U.S. Department
Of Transportation
**Federal Highway
Administration**

Refer to: HNG-21/SS-02

This is in response to your August 1 letter requesting Federal Highway Administration (FHWA) acceptance of your MICRO=LAM laminated veneer lumber breakaway signposts for use on Federal-aid highway projects. You enclosed a copy of an Engineered Wood brochure, a videotape and a Southwest Research Institute Report No. 06-1102-001 Dated July, 1986 containing full-scale crash test information.

BREAKAWAY FEATURE

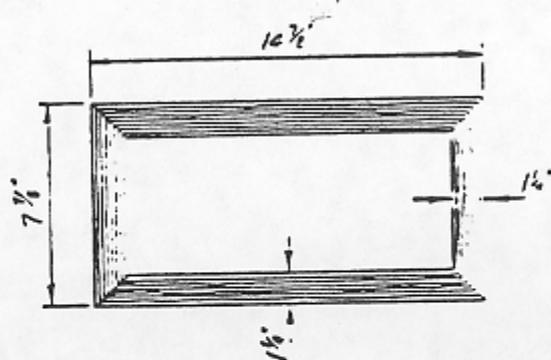
Your 14 7/8-inch by 7 7/8-inch laminated veneer lumber post having a wall thickness of 1 1/4-inches and having 45-degree mitered corners was tested. The post was placed in pre-drilled holes and backfilled. Four 1-inch diameter holes were then drilled on the two sides of the post parallel to the direction of travel. Two of the holes were at the 3-inch above ground heights and the other two holes were at the 18-inch height. A saw cut parallel to the ground was then made that connects each set of holes. Enclosed is a copy of the tested design for your ready reference.

One test was conducted with an 1,840-pound vehicle impacting the sign post at 20.6 m.p.h. Reported test results indicate a change-of-velocity of 7.8 feet/second. The second test was conducted with a 1,840-pound vehicle impacting the signpost of 58.7 m.p.h. Reported test results indicate a change-of-velocity of 8.8 feet/second. Therefore, the tested system meets the provisions of the new, but yet unpublished, 1985 American Association of State Highway and Transportation Officials (AASHTO) "Standard Specifications for Structural Supports for Highway Signs, Luminaires and Traffic Signals". We also infer this system meets the 1975 AASHTO specification since the 1985 AASHTO specification is more demanding.

Based on the above, the tested system is acceptable for use on Federal-aid projects if proposed by a State. We also infer your 7 7/8-inch square by 1 1/4-inch thick laminated

veneer lumber post is also acceptable. Furthermore, only one post is allowed within an 8-foot path.

This acceptance is limited to breakaway characteristics of the system and does not cover its structural features. Presumably, Trus Joist Corporation will supply potential users with sufficient information on structural design and installation requirements, including the need to size the sign panel and support for expected wind loading, to ensure proper support performance.

We anticipate that the States will require certification from Trus Joist Corporation that materials furnished have essentially the same mechanical properties and geometry as the materials used in the tests and that the support will meet the change in momentum requirements of the AASHTO specification.
